SB Number:	SB PF-015	Creation Date: 05/11/2008
Subject:	<i>The leading edge of paper bends.</i>	
Model:	PF-70/700/710

Affected models: PF-700: KM-3050/4050/5050
: PF-710: KM-C2520/3225/3232/2525E/3232E/4035E

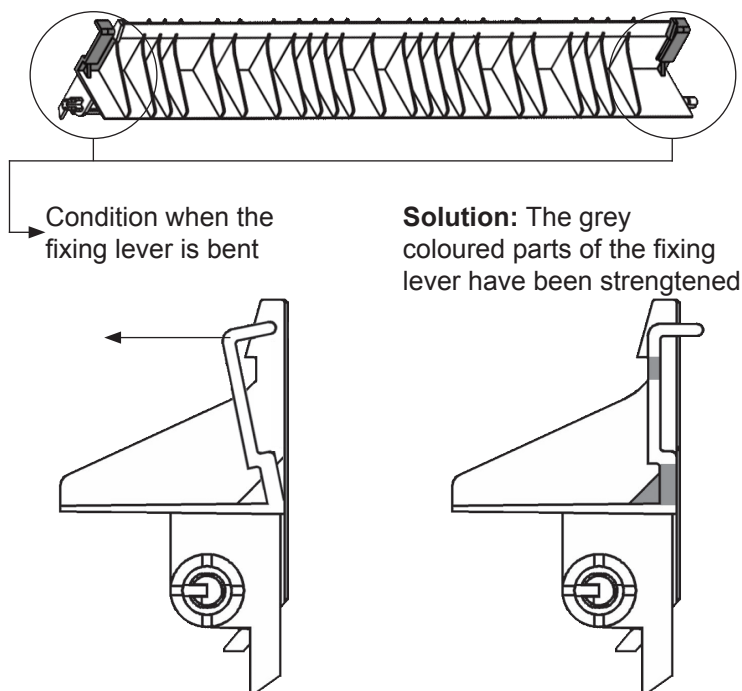
Phenomenon	The leading edge of paper bends.
Cause	The fixing lever of the guide vertical conveying left bends, and parts may brake off.
Solution	Parts of the fixing lever have been strengthened.

Grey coloured parts of the **guide vertical conveying left** (303J424011) have been strengthened.

Above shows the condition seen from the rear side of the machine.

Classification	<input type="checkbox"/> Entire stock rework <input type="checkbox"/> In-field modification at next visit <input checked="" type="checkbox"/> In-field modification by case <input type="checkbox"/> No modification necessary
Field measure	When the above mentioned phenomenon occurs, replace guide vertical conveying left 303J424010 (Called upper left guide vertical conveying 3AT07010 in the parts list of the PF-70) with guide vertical conveying left 303J424011.
